**Report to the Future Melbourne (Planning) Committee****Agenda item 5.2****Ministerial Planning Referral: ID-2020-4****13 October 2020****12 Riverside Quay, Southbank and the triangular parcel of land to the southwest****Presenter:** Evan Counsel, Director Planning and Building**Purpose and background**

1. The purpose of this report is to advise the Future Melbourne Committee (FMC) of Melbourne Planning Scheme Amendment C391MELB which seeks to facilitate the redevelopment of the land located at 12 Riverside Quay, Southbank and the 215m<sup>2</sup> triangular parcel of land to the southwest (refer Attachment 2 – Locality Plan).

### MINISTERIAL PLANNING REFERRAL

**Proposed Ground Floor Plan with mark-ups by officers (Source: Hayball)**

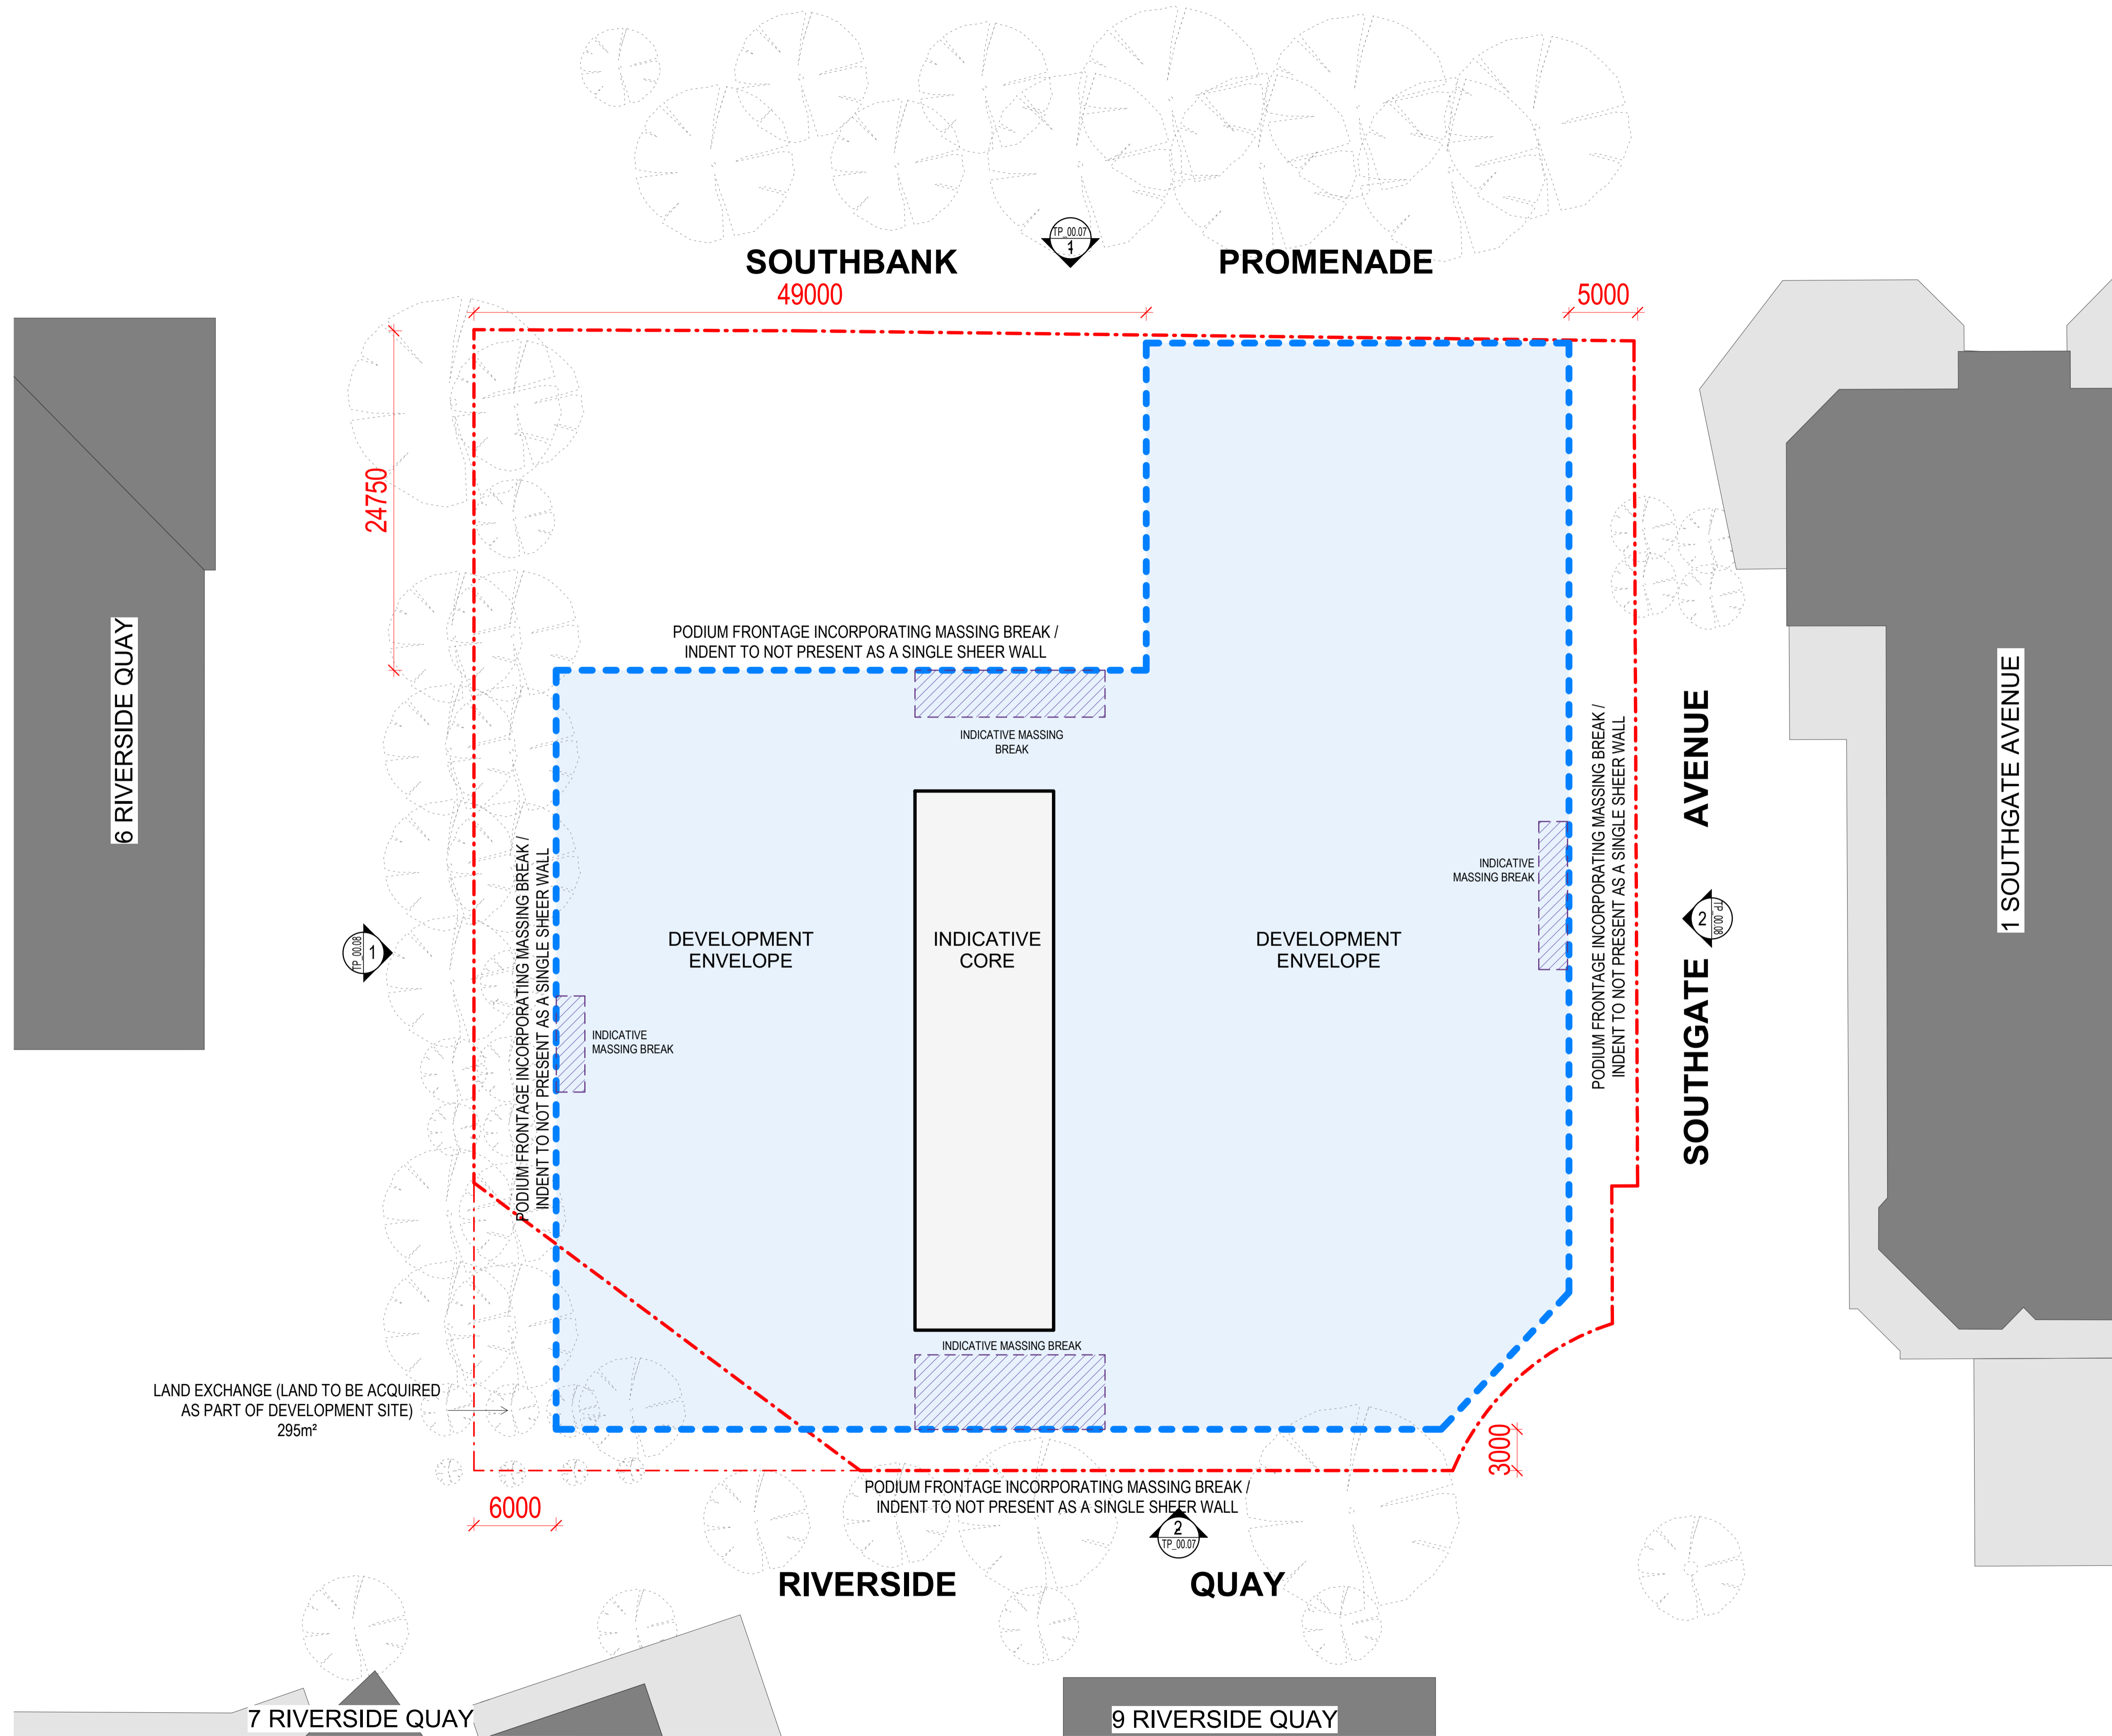
**MARK-UP 18/09/2020**  
**APPROXIMATE EXTENT OF EXISTING**  
**BASEMENT & POTENTIAL LAND TO BE**  
**VESTED TO COUNCIL TO THE EAST**  
**AND SOUTH BOUNDARIES**

6m setback for landscaping and outdoor dining

Land within the 215m<sup>2</sup> triangular parcel of land to the southwest to be built on

Land within the 215m<sup>2</sup> triangular parcel of land that will provide landscaping and outdoor dining

**Figure 1: Singular Building**

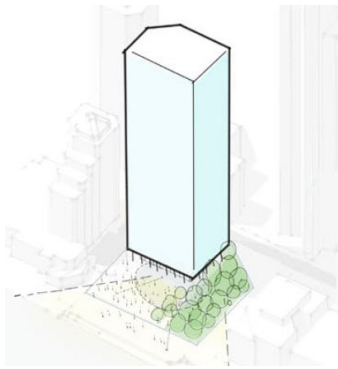
Key concerns:

- Height and form does not respect the established character on the south side of the river.
- Does not define the promenade.

**Figure 2: Urban Campus**

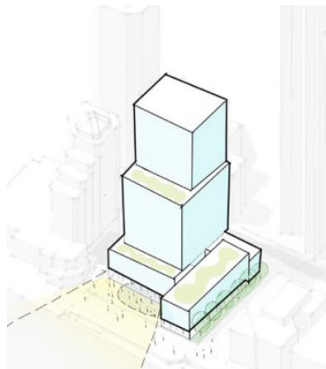
Key concerns:

- The public open space in the NE corner is encumbered by the basement.
- Form requires further testing.

**Figure 3: Hybrid Campus**

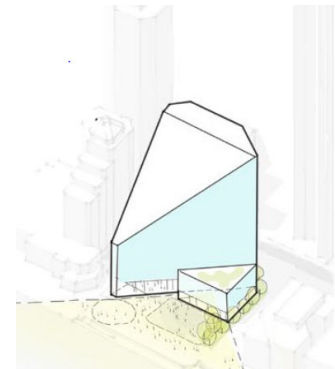
- The 'hybrid campus' indicative form defined by various constraints shows a low built edge that rises at an angle from the promenade (see Figure 3 below). We do not support bringing the tower height forward to the promenade. There is potential for higher built form to the southern part of the site, however the forms must work together effectively.

Key concerns:

- Height and form does not respect the established character on the south side of the river.
- Does not define the promenade.
- Deep floorplates and heat load.

**Figure 4: Hybrid Campus Ground Plane**

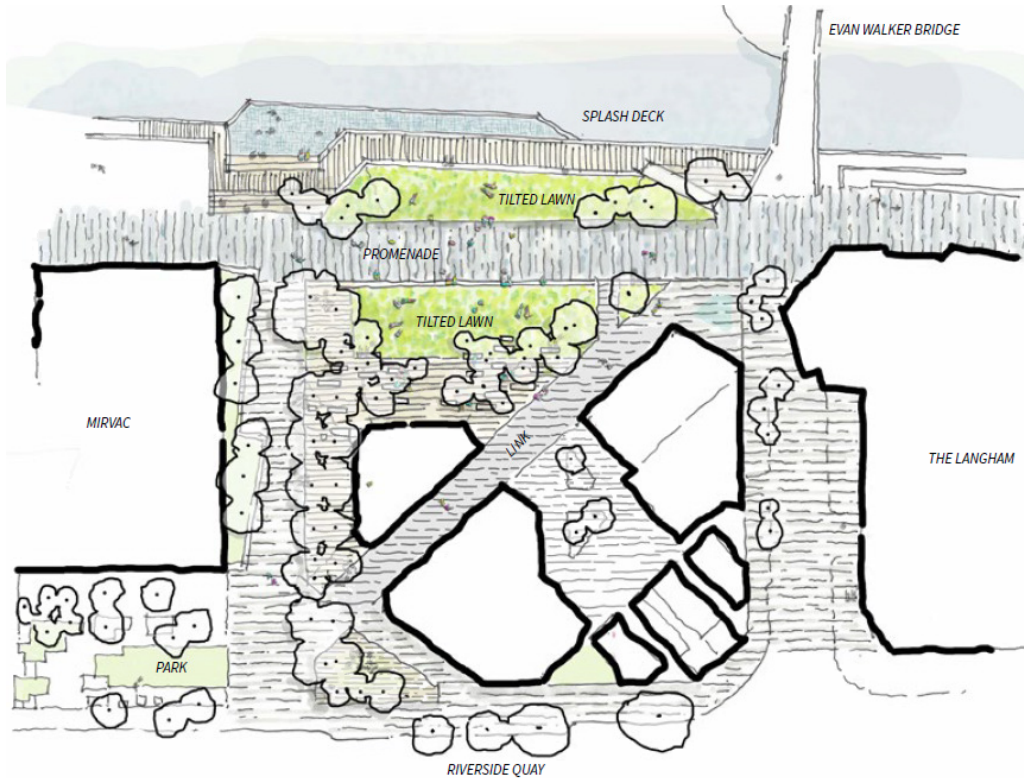
- Users of public open space do not have regard for title boundaries, but will respond to a well designed and proportioned area. The public benefit will be more valuable if it is improved together with Southbank Promenade, rather than an isolated onsite offer. We are not convinced that a tilted grassed plane is an appropriate response in this location (see Figures 4, 5 and 6 below).

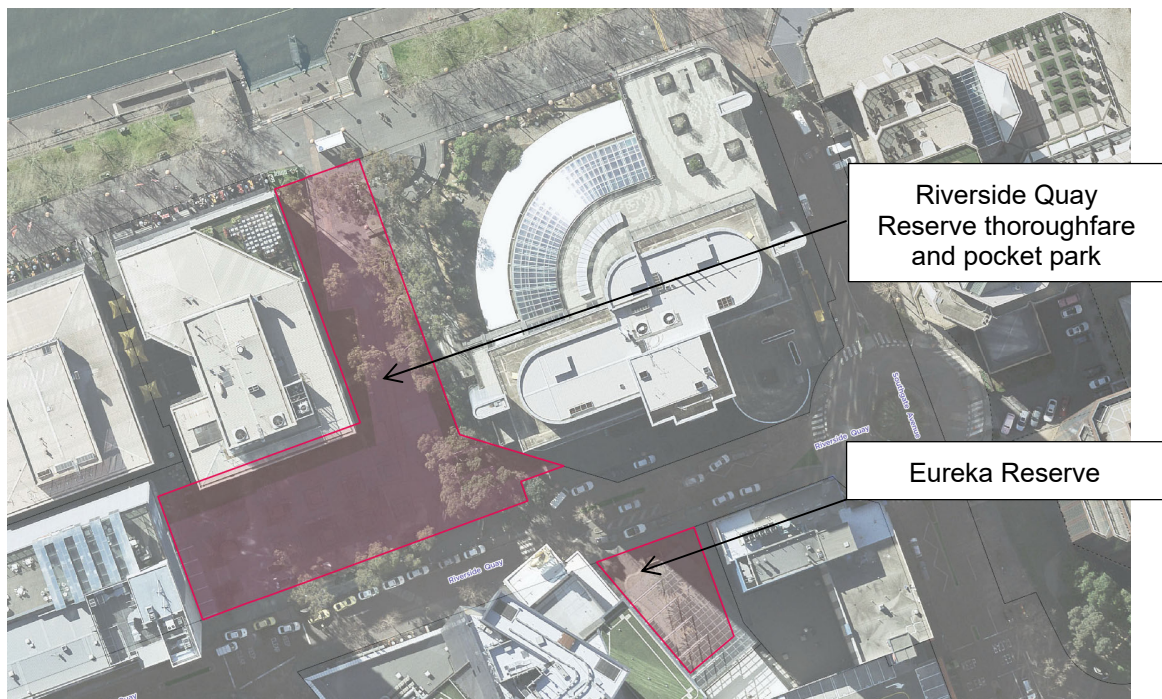
Sunlight to the pocket park was one of the key design principles during the early testing of different massing options that resulting in the 'hybrid campus' wedge form (see figure 3 in section 2.3 of this report). However, the OVGA found that sunlight to the pocket park should not be a primary driver for built form on the site and that the following design principles were more important:

- Enhancing the orthogonal movement patterns around the site.
- Providing definition and containment to Southbank Promenade to maintain the linear pedestrian experience.
- Parallel, low rise built form along the promenade to maintain a human scale, complement the width of the Yarra River and emphasise the river edge.
- Higher built form stepping away from the promenade.
- A building form that responded to its place and context.

Further, it is considered that solar access to the pocket park is already compromised by the existing Esso Building and the Mirvac buildings at 2, 4 and 6 Riverside Quay and that overshadowing from the development will not unreasonably prejudice the amenity of the space in this context.
